Technical Bulletin

Tension setting procedure for PSA 2.0 HDI engines

GATES REFERENCE :	5524XS/K015524XS/K025524XS/KP15524XS/ KP25524XS	
MAKE :	CITROEN, FIAT, PEUGEOT, SUZUKI	
MODEL :	Various	
ENGINE :	2.0 D	
ENGINE CODE :	DW10ATED, DW10BTED, W10CTED, DW10TD, RHV, RHX, RHZ

Fig. 2

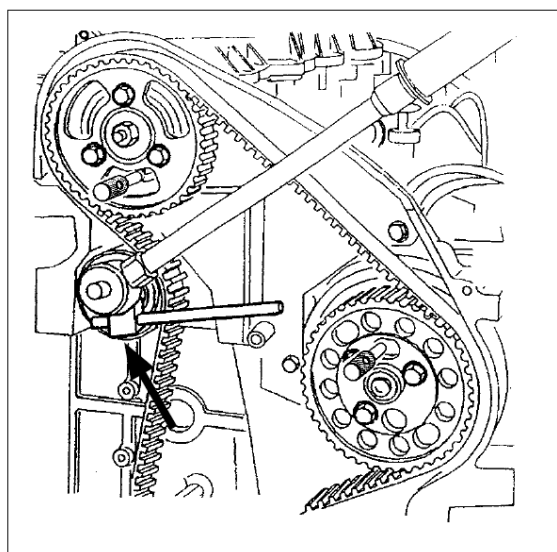
- This tool is needed in order to turn the tensioner and hold it in place while tightening the locking bolt (25 Nm)(Fig. 2).

Fig. 3

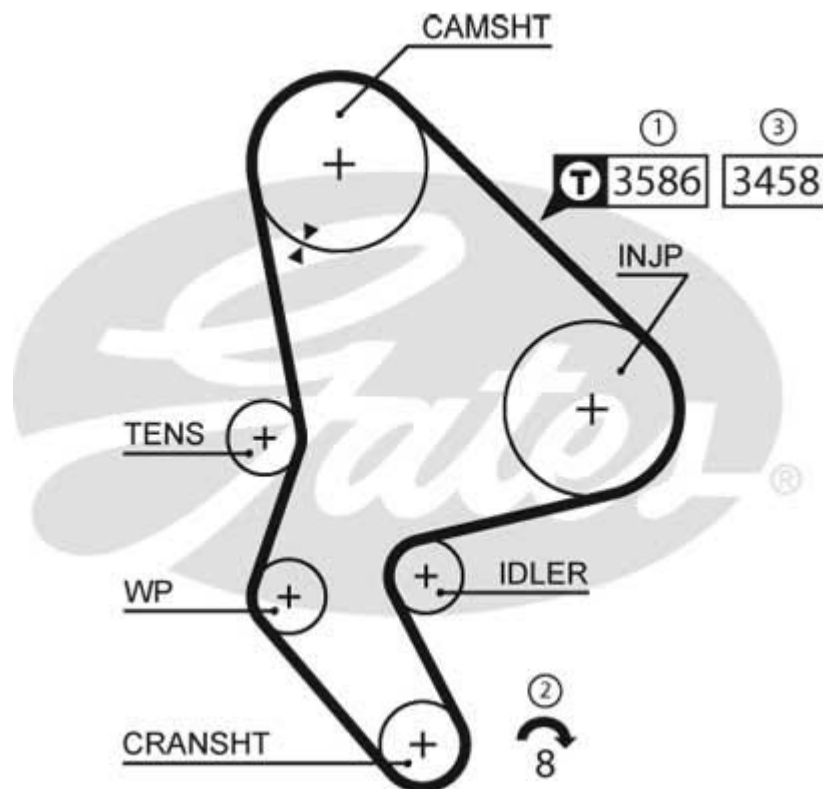
- ① - Initially, the belt has to be installed at a higher than normal tension (pretension).
The tension is measured with a Gates STT-1 tension tester in the span between the camshaft and the injection pump. Enter code 3586
- ② - The crankshaft pulley is then rotated 8 revolutions, clockwise
- ③ - The tension is then adjusted to the final level, and the value is again confirmed with the STT-1 tension tester. Enter code 3458

The procedure will be visualised on the PowerGrip[®] Kit and belt box label as in Fig 3.
